4727 12th Avenue NE  
APN: 674670-1970  
Zoning: SM-U 75-240 (M1)  
Overlay: University District NW Urban Center Village  
Lot Area: 4500 sf  
Current Use: Single Family Residential

## DREC RESPONSE

DREC PACKAGE | 4727 12TH AVE NE

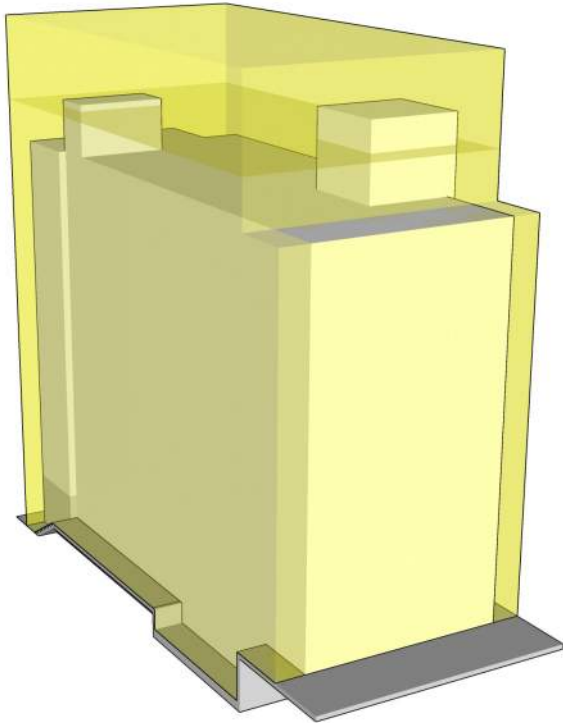
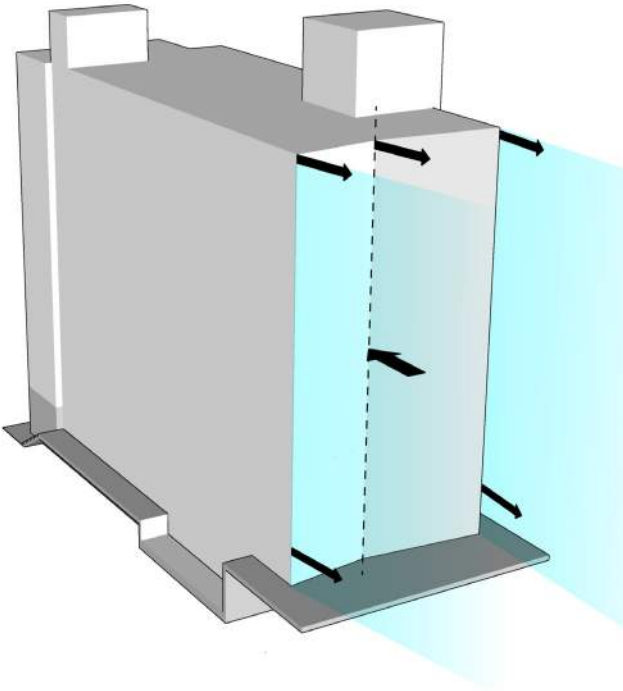
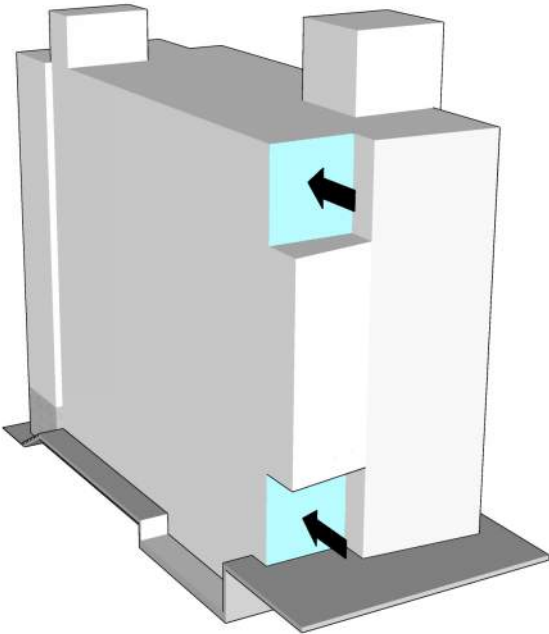
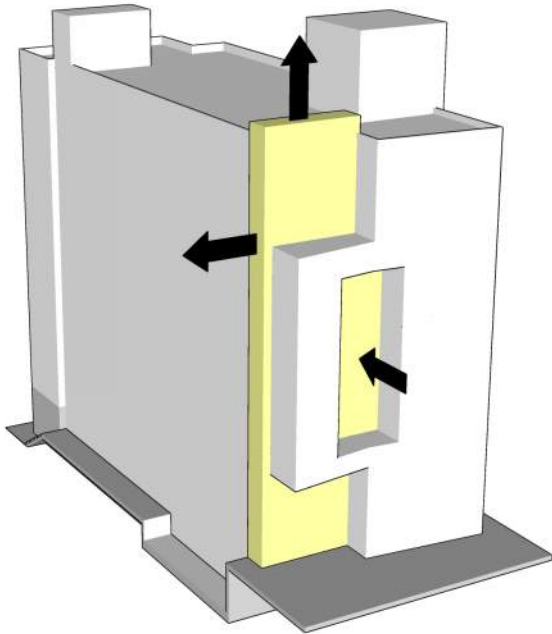
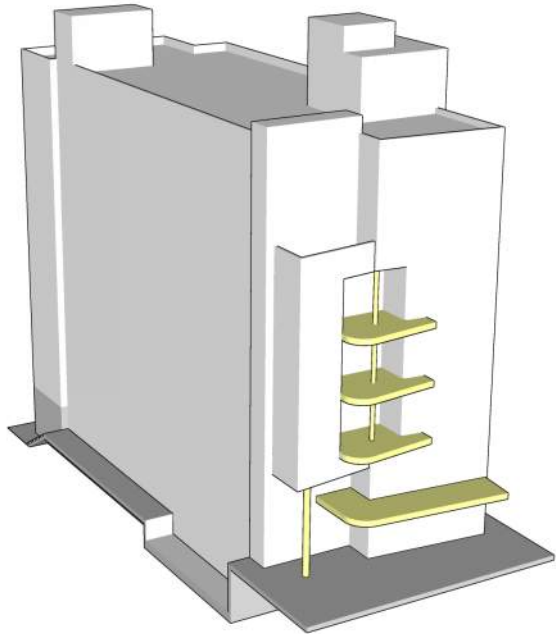
The Board acknowledged that at EDG they recognized the fun and playful aspects of the different elements on the street facing façade which included the entry and front canopy, the balconies, the wood accent, the framed box, and the various angled elements. The Board supported the three-story groupings of balconies and windows, the column element and the two-story entryway. They also supported the different façade depths that the balconies and other elements helped to shape. However, the Board struggled to see how of these elements work together to create one nicely composed façade. The Board suggested that if the design language centered on columns or groupings of three, then those elements could be deployed across the whole of the design as one approach. Finally, the Board disagreed with the Design Team’s assessment that the long skinny site was a detriment but rather a rare situation in which unique things could be done to create visual interest.

The diagrams below show the major gestures and underpinning of the developed design. Starting broadly with the allowable zoning envelope, the primary façade is pressed in at a near-center hinge point, engaging the streetscape and drawing activity inward. Eroding two-story volumes at the entry and near the top of the building reduces visual mass and creates vital outdoor spaces. Articulated material application enhances and focuses the façade, while smaller scale elements enrich the street and residential experience.

2. ELEVATOR TOWER

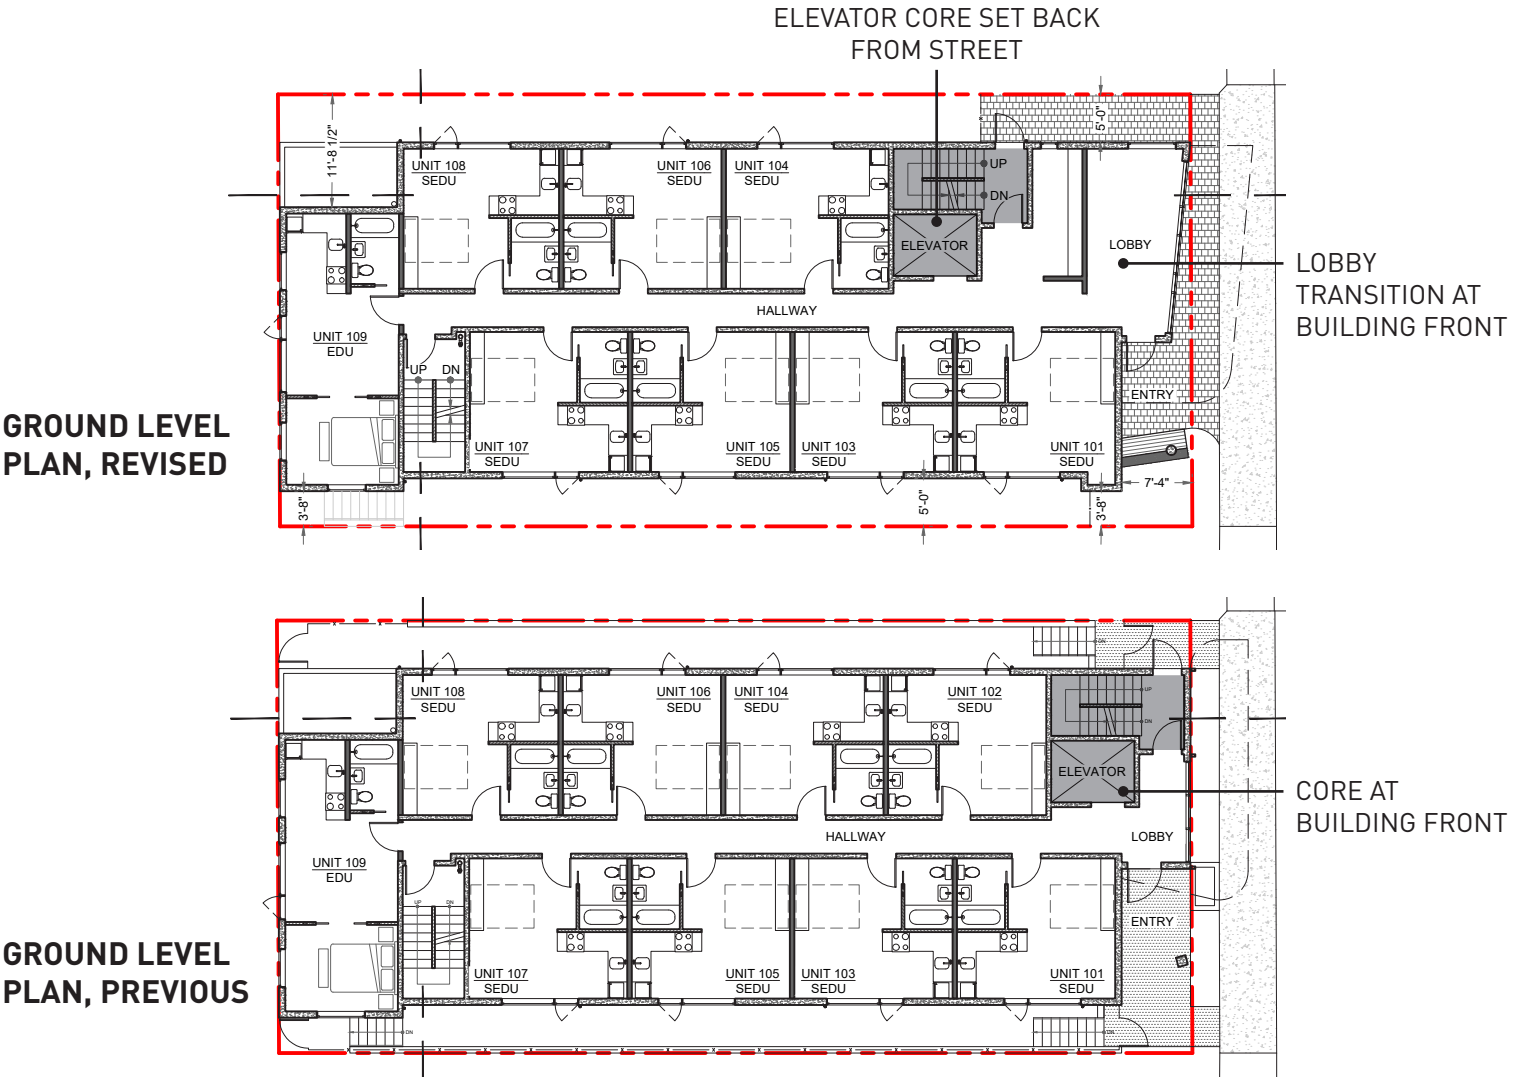
The Board asked if the design team considered placing the elevator core back away from the street, possibly swapping it with one of the living units. The Board stated that in its current form they did not support the design of the elevator tower and recommended that it could either be relocated allowing for the placement units along the street edge for greater transparency and street engagement, or redesigned in a manner that would allow the elevator core to engage directly with the street itself. One possibility could be the use of a transparent elevator or an intervening amenity space such as a lounge between the street and the elevator.

- a. The Board requested that the applicant develop an alternative location or design for the elevator tower that better aids in activating the street. (PL2-B-1, PL2-B-3)

The elevator was relocated, setback approximately 20’ from its previous location. From the 2nd floor up, dwelling units take the place of the vertical circulation core and overlook the street, maintaining transparency and adding daily activity. At the ground floor a lobby is introduced as a transitional space from the street to the core of the building. Broad sections of glass generate substantial transparency and link the building interior with the dynamics of a busy pedestrian street.

BASEMENT LEVEL PLAN SHOWING INTERNAL TRASH ROOM

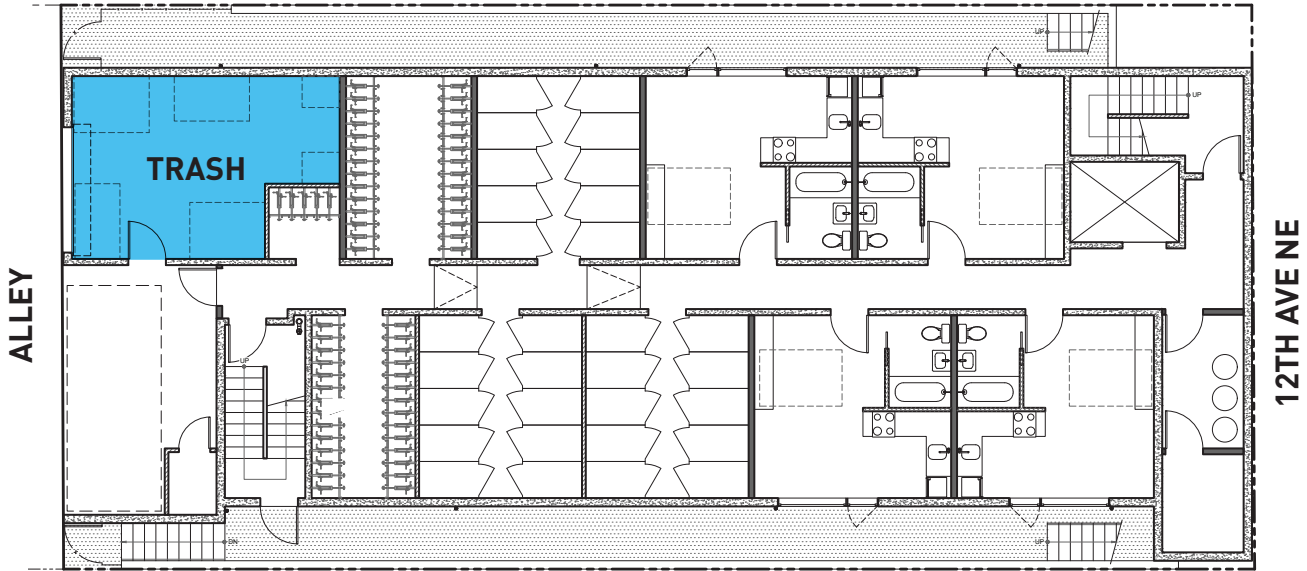
- a. The Board directed the applicant to create an enclosed trash room within the building footprint or within the footprint of where it is currently indicated on page 29 of the EDG packet. The Board was also supportive of either relocating the trash room to the area of the mechanical room or placing it in a more centralized location making it easier to install a trash shoot as a viable alternatives. (CS2-II).

The trash room is now enclosed within the building footprint, accessed for pick-up through a large coil-up door. This minimizes impacts to adjacent properties. A centralized location proves to be impossible to service adequately, again due to the narrow width of the site. The location at the alley keeps trash out of the core of the building and provides easy access for pick-up. While we recognize the convenience that is offered by a trash chute it is not a requirement and is not provided. We worked with Seattle Public Utilities on the configuration and size of the trash room to satisfy their requirements for access and pick-up and have secured their approval of the layout.

SOUTH ELEVATION WINDOW ADJACENCY DIAGRAM

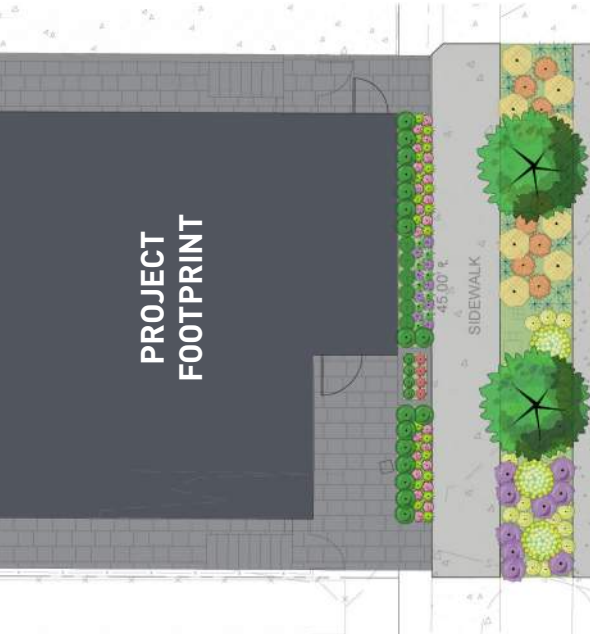
The Board observed that the design proposal did not meaningfully respond to the close proximity of the elevator corridor of the building to the south. The Board thought the units on the south facing façade might be too close to the adjacent building and suggested further review of the floor layout and possible relief to the stack of units that would look out directly onto the adjacent elevator core. The Board agreed with the public comment that the ‘sunken’ walkways located along the north and south of the building could be used as throughways and loitering spaces for transients as they have direct access to the alley. Board members discussed how the spaces could possibly be broken up with a combination of hardscapes, softscapes, or terraced landscaping instead of stairs in order to make the spaces less of an attractive area but decline to make this a specific directive.

- a. The Board stated that they would like to see gates installed to discourage any unauthorized use of those walkway spaces. (PL2-B, CS2-II)

The elevation diagrams show the direct relationships between fenestration on the project façade and the adjacent buildings. Window spacing was modified to reduce overlap at the elevator tower and the patio doors of the adjacent building. Gates have been added to limit and discourage access to the sunken side yard spaces. We are maintaining the stairs from the window wells to maximize ease of egress in case of emergency.
